Service Bulletin Document: 159-054-00 Revision: 1 Date: November 14, 2024

SERVICE BULLETIN

Subject: Swing Suspension Load Cell / Gimbal Inspection

Helicopters Affected: AS350 and AS355

Figure 1 Load Cell/Gimbal Joint Disassembly

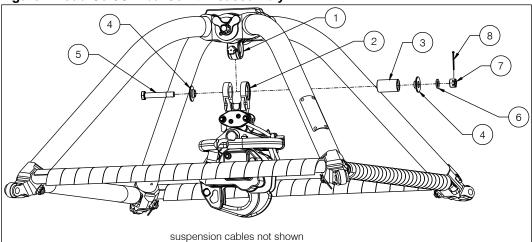
- 1. Disconnect the electrical connections, ground strap and mechanical release connections at the aircraft.
- 2. Remove the Swing Frame Assembly from the helicopter by removing the four quick release pins at the shackles on the aircraft hard points.
- 3. Remove the cotter pin (8), nut (7), washer (6), Retaining Bushing (4) from the end of the bolt (5).

- 4. Remove the bolt and Retaining Bushing (4) under its head and slide the Gimbal Shaft (3) out from the Gimbal (1) and Load Cell (2) while supporting the cargo hook.

- 5. Visually inspect the Gimbal Shaft for signs of wear, such as pitting, galling, or reduction in diameter. If the diameter is less than .732 in. (18.6 mm), the Gimbal Shaft must be replaced. There should be no visible wear, except for light burnishing of the outside diameter surface. If the burnishing can be removed using Scotch Brite (3M P/N 7447), it is considered light.

Figure 2 Load Cell Inspection

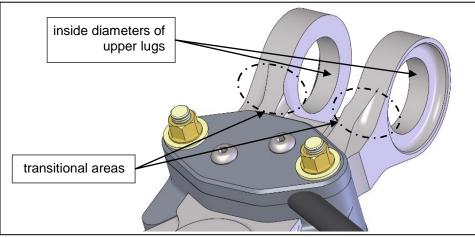
- 6. Inspect the inside diameters of the upper lugs of the Load Cell (reference Figure 2) for signs of wear such as pitting, galling, or elongation of the holes. If the inside diameter of the lugs exceeds .759 in. (19.3 mm), the load cell must be replaced. There should be no visible wear, aside from light burnishing of the inside diameter surfaces. If the burnishing can be removed using the Scotch Brite, it is considered light.

Visually inspect for cracks around both lugs, including the transitional areas (reference Figure 2) where the lugs transition into the flat portion of the Load Cell. Inspect these areas on both sides.

Figure 3 Gimbal DU Bearing Inspection Criteria

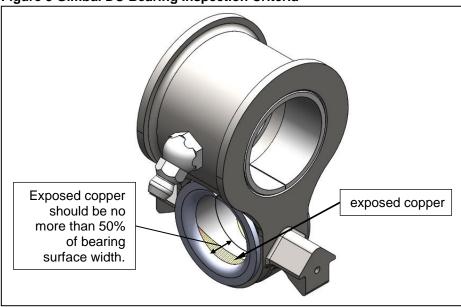
- 7. If the Load Cell requires replacement, refer to the applicable ICA manual as referenced in Table 2.
- 8. Inspect the flanged DU bearings of the Gimbal (1) that interface with the Gimbal Shaft. As these bearings wear, the low-friction PTFE layer is removed, exposing the copper layer below. Across the width of the bearing surface, no more than 50% should be the exposed copper layer (reference Figure 3).

Figure 4 Upper Joint Parts

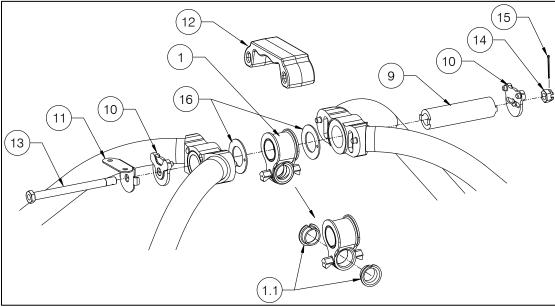
- 9. If the DU bearings require replacement, disassemble the upper joint of the swing frame to remove the Gimbal per the following. Refer to Figure 4 and Table 3 for item numbers in parentheses ().
 - a. At the upper pivoting joint, remove the cotter pin (15) and nut (14) from the end of the bolt (13) and remove the Shaft Cap (10).

- b. Remove the bolt, bracket (11) (present on CRFS configurations only) and the other Shaft Cap (10).
- c. While supporting the Swing Frame halves, slide the Pivot Shaft (9) out to remove the Gimbal (1).
- d. Remove the DU bearings (1.1) by tapping out the first one from the opposite side with a flat screwdriver or similar and hammer and then pushing out the other one.
- e. Press in replacement DU bearings with wet zinc chromate primer (TTP-1757 or equivalent) applied to mating hole of Gimbal.
